4th April 2022
Your Ref. 200328
Our Ref. P122264-1001

BRE Review of March 2022 Revision of Wind Microclimate Reports in Respect of Outline Planning Application 200328 at Vastern Court, Caversham Road, Reading

Figure 9.3 Proposed Development Assumed Intended Pedestrian Use

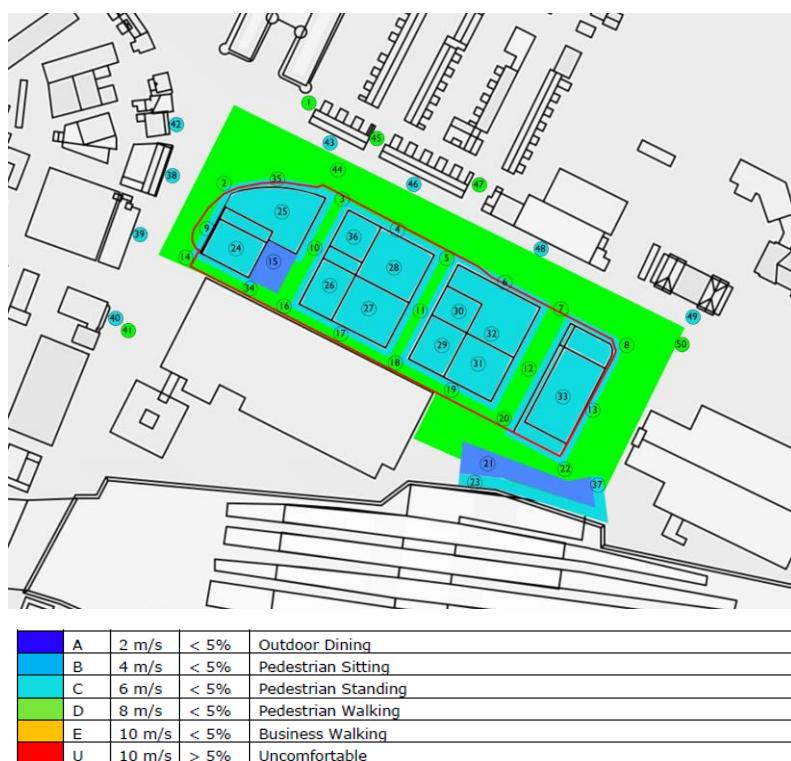
Figure 9.3, included for convenience below, shows an area to the south of the proposed development between measurement locations 21 and 37 and a large area around measurement location 15 which are designated as assumed outdoor dining areas.

There does not appear to be a discussion of the suitability of wind effects in these two areas for outdoor dining. The wind conditions at measurement location 15 are classed as “Uncomfortable”, this is five categories more severe than the target category and would be major adverse (note that major adverse is classed as being three categories worse than the target category – so this is a very severe major adverse condition). The wind conditions in the area between measurement locations 21 and 37 is classed as suitable for “Pedestrian Walking”, again a major adverse condition.

BRE Comment: A discussion of the usage of these two outdoor dining areas and appropriate mitigation must be specifically included
